# Access Compliance Report

## Public Rights-of-Way

### (Curb Ramps)

Intersection ID: 29501	Main Street: REDDMAN_RD	Cross Street: SOUTHWOOD_OAKS_LN	Location: SE
ADA ID: 5A20A44ACCAA	Ramp Type: PerpDiag	Initial Pass/Fail: Fail	Overall Compliance: No
		Severity Score: 25

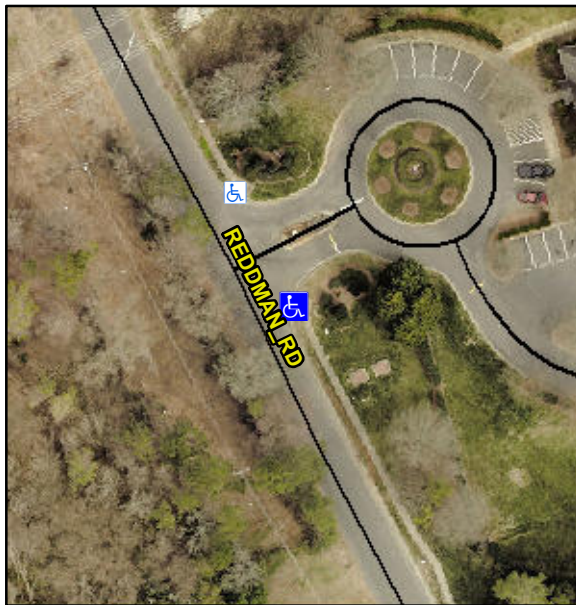
**Not Found, R304.5.3**

Compliance	Description	Data	Compliance	Description	Data
N/A	Ramp Length (in)	47.0	Yes	Ramp Slope (%)	8.1
Yes	Ramp Width (in)	48.0	No	Ramp XSlope (%)	8.0
N/A	Flare Type LT	N/A	N/A	Flare Type RT	N/A
N/A	Flare Slope LT (%)	N/A	N/A	Flare Slope RT (%)	N/A
N/A	Flare Traversable LT?	N/A	N/A	Flare Traversable RT?	N/A
N/A	Landing Length (in)	N/A	N/A	DWS Provided?	N/A
N/A	Landing Width (in)	N/A	N/A	DWS Contrast?	N/A
N/A	Landing Slope (%)	N/A	N/A	DWS Length (in)	N/A
N/A	Landing X Slope (%)	N/A	N/A	DWS Full Width?	N/A
N/A	Landing Curb? (Y/N)	N/A	N/A	DWS Offset (in)	N/A
N/A	Shared Landing?	N/A			
N/A	Gutter Ponding?	N/A	N/A	Gutter Slope (%)	N/A
N/A	Gutter Lip Ht (in)	N/A	N/A	Gutter X Slope (%)	N/A
N/A	Painted X Walk1?	No	N/A	Painted X Walk2?	No
	X Walk 1 Direction	To NW		X Walk 2 Direction	To W
N/A	X Walk 1 Width (in)	N/A	N/A	X Walk 2 Width (in)	N/A
	X Walk 1 Slope (%)	2.9		X Walk 2 Slope (%)	0.7
	X Walk 1 X Slope (%)	2.6		X Walk 2 X Slope (%)	4.8

**Remove & Replace Curb Ramp With Two New Directional Ramps or Equivalent.**
